CITY OF DULUTH

STAFF REPORT

File Number	PL 15-050	Contact	Steven Roberson, 218 730 5295	
Application Type	Special Use Permit, 8 Unit Townhome	Planning Commission Date	May 12, 2015	
Deadline for Action	Application Date	April 16, 2015	60 Days	June 15, 2015
	Date Extension Letter Mailed	April 22, 2015	120 Days	August 14, 2015
Location of Subject	Northeast corner of Mississippi Avenue and Lyons Street			
Applicant	Green Capital, LLC.	Contact	Jason Ross	
Agent	Greg Strom, Architect	Contact	gps.foundations@gmail.com	
Legal Description	See attached			
Site Visit Date	April 18, 2015	Sign Notice Date	April 28, 2015	
Neighbor Letter Date	April 24, 2015	Number of Letters Sent	38

PL15-050, SE Corner of
Lyons and Mississippi

DRAWING TITLE: LANDSCAPE PLAN

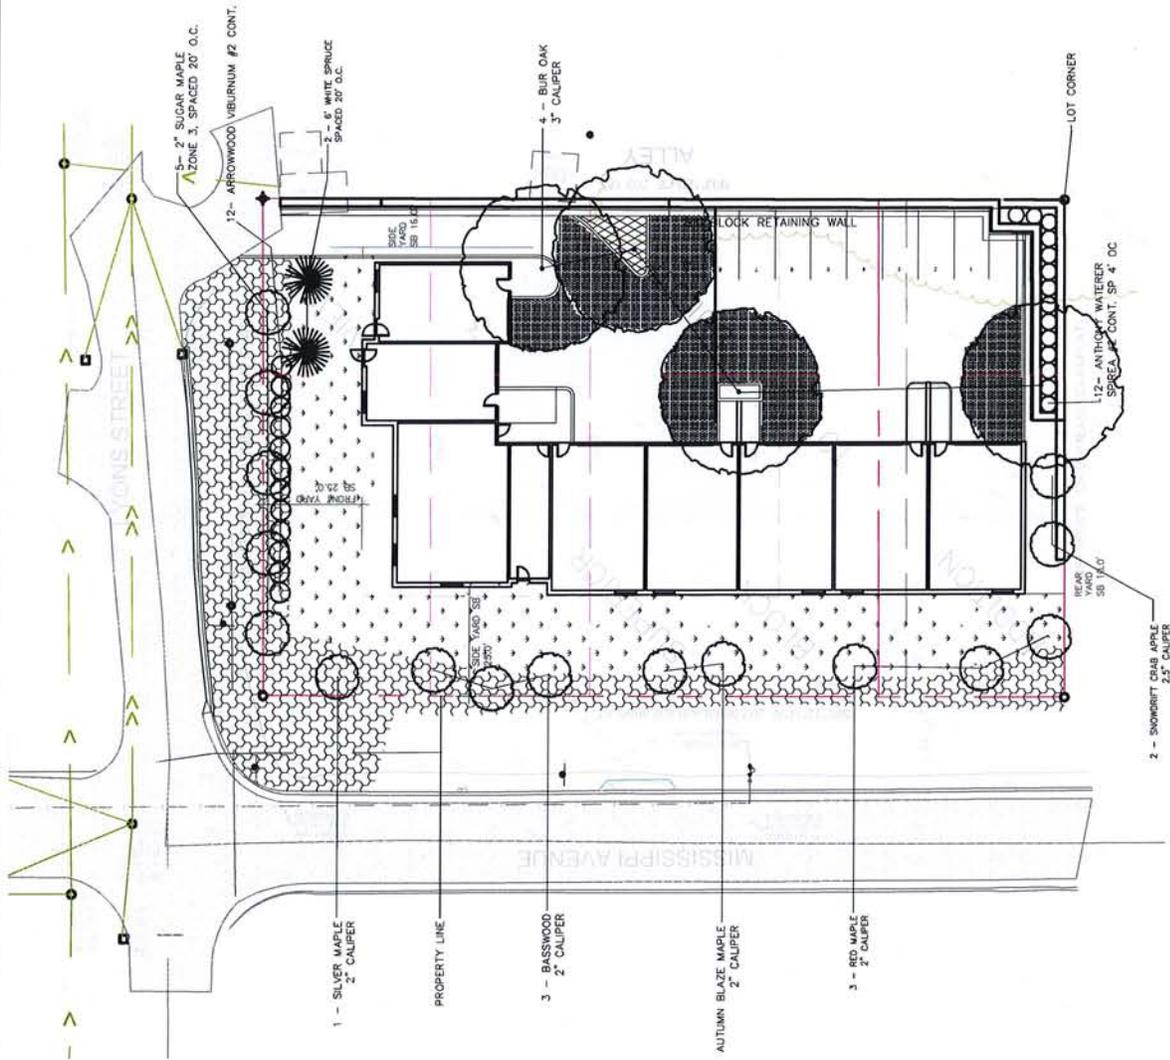
- 4) Lighting plan and sustainability checklist required with building permit application.
- 5) Landscaping plan be revised to show compliance with UDC, including one tree per 20 feet on rear property line per 50-20.1.
